# PARC DULLES II

Zoning Map Amendment 2002-0017

## *– Statement of Justification –*

Response to Third Round Referral Comments

**FIGURE 1: OPEN SPACE PLAN**

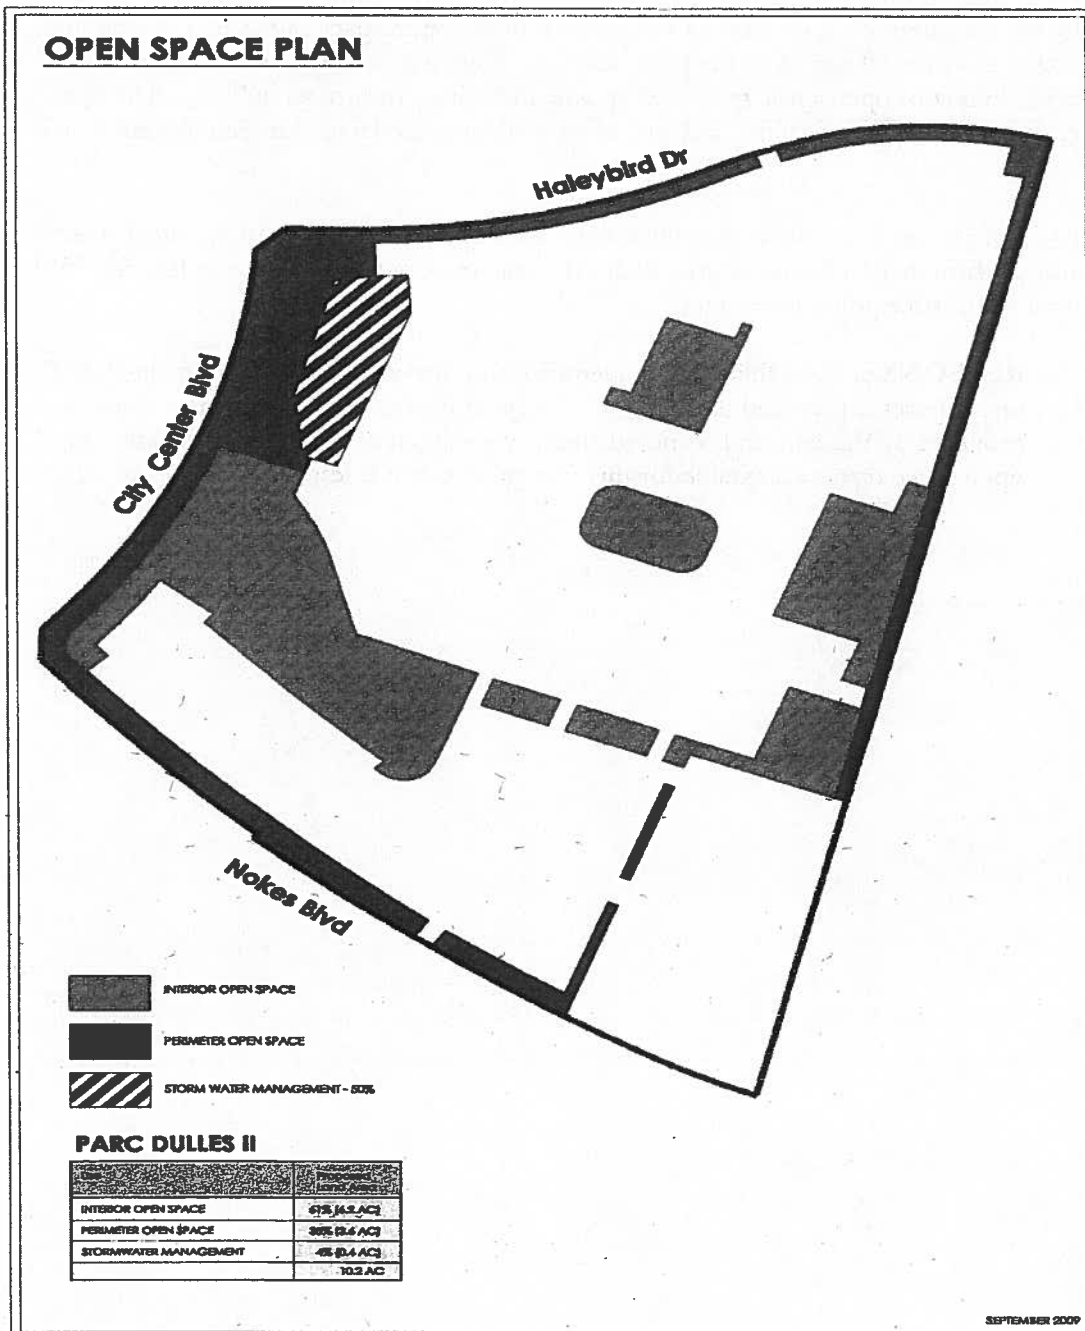
***Additional Staff Comment:*** *"Approximate Active Rec Space" on sheet 4 still adds up to less than 86,400 square feet. The response (p. 16) indicates the pool area is 31,400 square feet, which is not consistent with sheet 4. Ensure the minimum amount of active recreation space is demonstrated on sheet 4.*

**RESPONSE:** An exhibit which identifies and provides area measurements for all open spaces is provided (see Figure 1). A great deal of high quality open space is provided on this site, and, as noted above, we suggest that the minor variation in open space mix is acceptable for this site, given that it is less than 50 acres in size.
